**Development Facilitation Team (DFT) – Review Comments**

**DRB Project No: PR-2020-003484 Date: 06/28/2023 Agenda Item: #9 Zone Atlas Page: E-10**

**Application For: SD-2023-00048 – PRELIMINARY PLAT (DHO)**

## Development Hearing Officer Planning - Case Comments

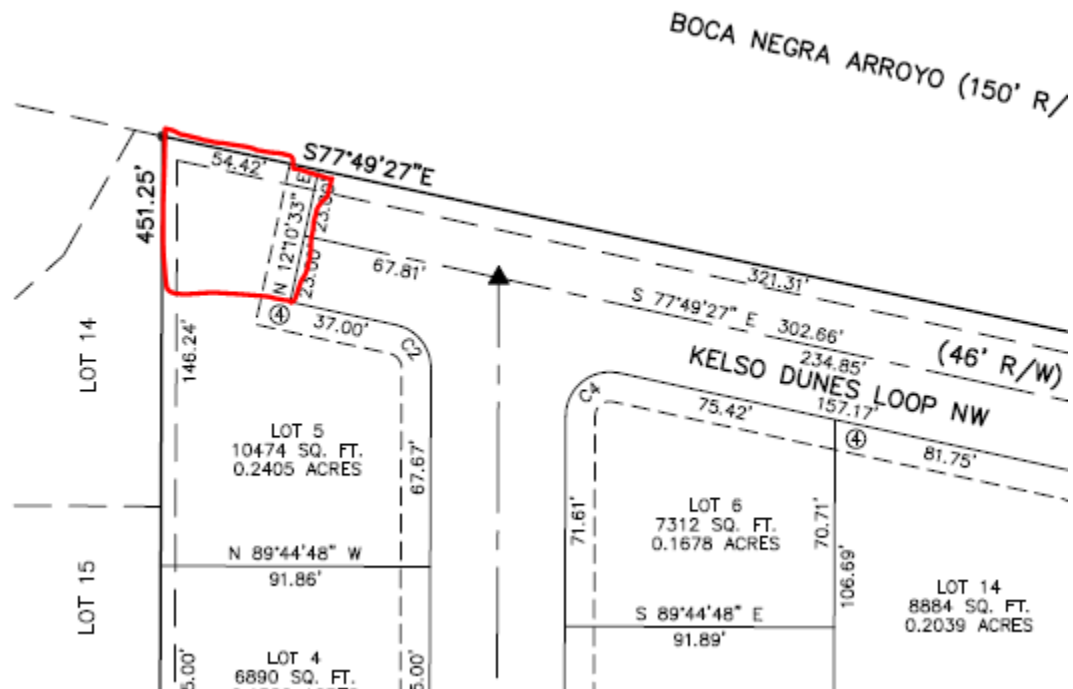
**Updated 6.23.23** Change the maintenance note of Tract A (pond) to be the Homeowner's Association, not just 'owner'; city maintenance is not provided for Tract A. The landscape buffer in the northwest corner of the subdivision should be in a separate tract with a note as shown on the next page.

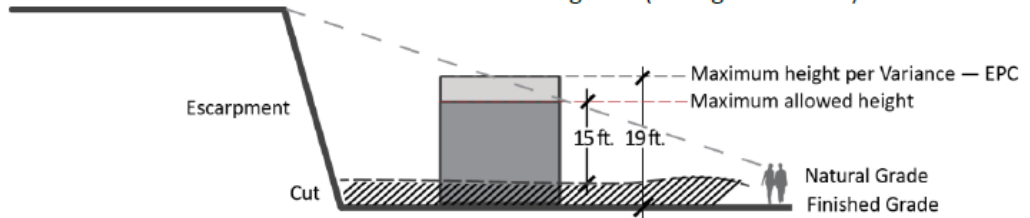
**IDO 3-6(E) The parcels are in the VPO-2 Height Restricted Sub Area. Identify the allowable structure height vis a vis grading plan.** 'Building and/or structure height shall not exceed 15 feet, as measured from natural grade.'

~~**\*Show height measurements from finished grade and natural grade. \*Clarify if standards are being met.**~~

- ✓ The applicant has shown height measurements from finished grade and natural grade and established maximum building heights that do not exceed 15 feet.

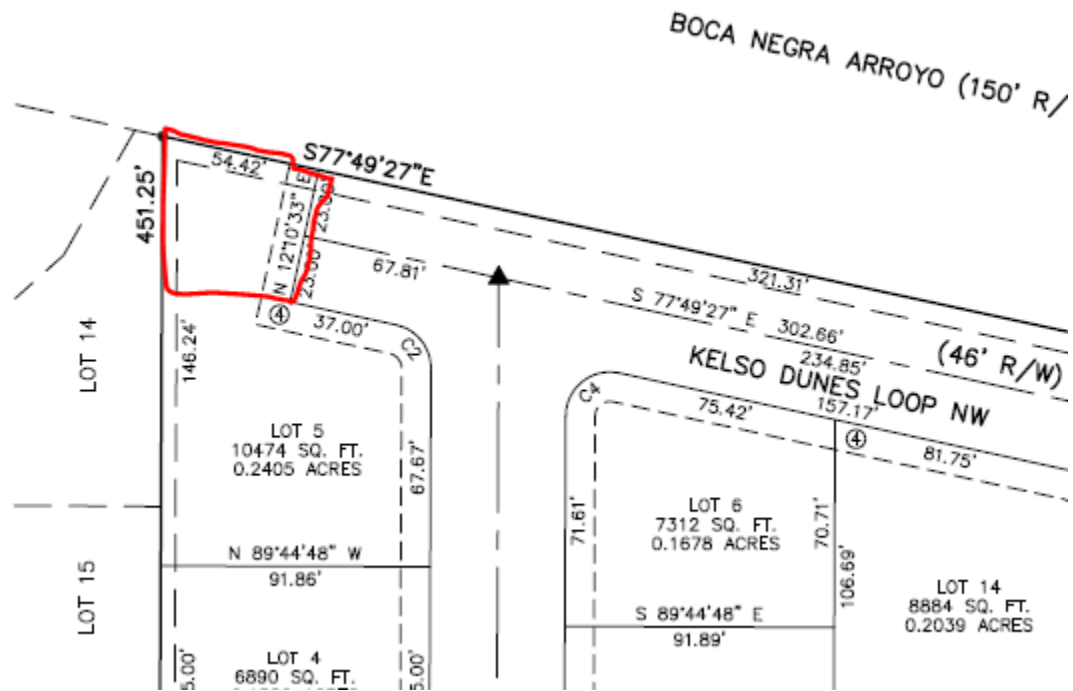
**Updated 6.23.23** Change the maintenance note of Tract A (pond) to be the Homeowner's Association, not just 'owner'; city maintenance is not provided for Tract A. The landscape buffer in the northwest corner of the subdivision should be in a separate tract with a note as shown on the next page.

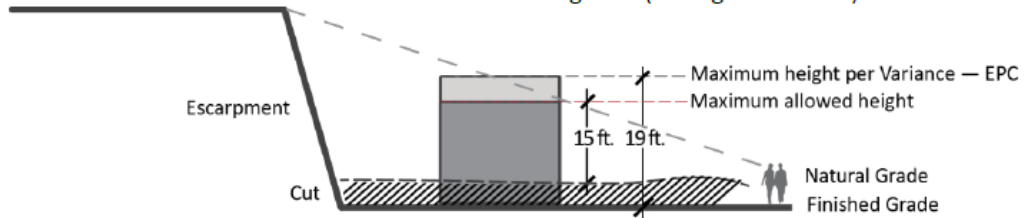
**IDO 3-6(E) The parcels are in the VPO-2 Height Restricted Sub Area. Identify the allowable structure height vis a vis grading plan.** 'Building and/or structure height shall not exceed 15 feet, as measured from natural grade.'

~~**\*Show height measurements from finished grade and natural grade. \*Clarify if standards are being met.**~~

- ✓ The applicant has shown height measurements from finished grade and natural grade and established maximum building heights that do not exceed 15 feet.
